PRODUCT / PROCESS CHANGE NOTIFICATION

PCN-000818

Semtech Corporation, 200 Flynn Road, Camarillo CA 93012			
Change Details			
Part Number(s) Affected: SX1272IMLTRT SX1273IMLTRT		Customer Part Number(s) Affected: <input checked="" type="checkbox"/> N/A	
Description, Purpose and Effect of Change: For business continuity purposes, Semtech will start using qualified alternate sources for test for the above-mentioned parts. The production final electrical test for these parts is currently performed at Carsem on Teradyne Flex testers. This test has been validated also at Greatek (Taiwan) on Teradyne Flex testers.			
Change Classification	<input checked="" type="checkbox"/> Major <input type="checkbox"/> Minor	Impact to Form, Fit, Function	<input type="checkbox"/> Yes <input checked="" type="checkbox"/> No
Impact to Data Sheet	<input type="checkbox"/> Yes <input checked="" type="checkbox"/> No	New Revision or Date	<input checked="" type="checkbox"/> N/A

Qualification of Greatek Taiwan as a second source test supplier for LORA and ISM products

Carrier tape for Greatek (New)

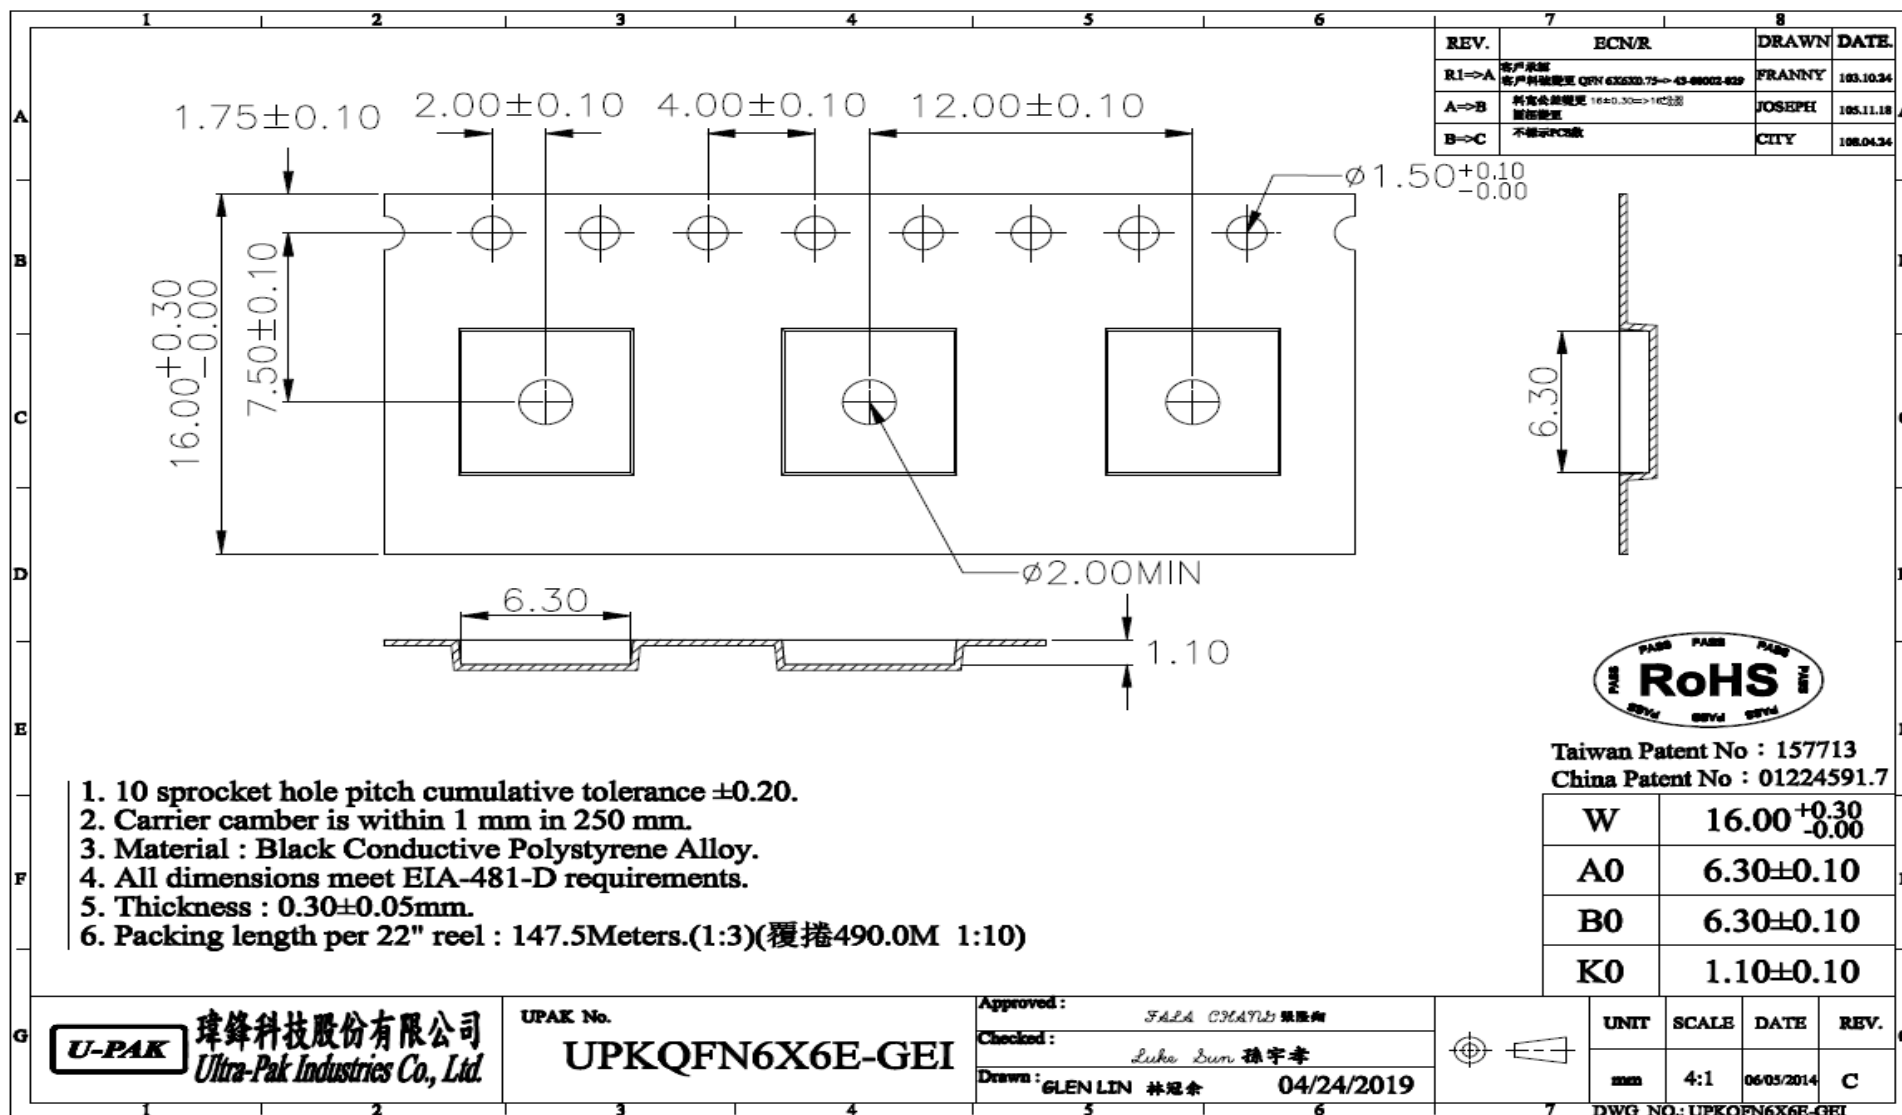
Carrier tape 6x6 comparison (Carsem Vs Greatek)

**Carrier tape suppliers are different
but critical dimensions are the same.**
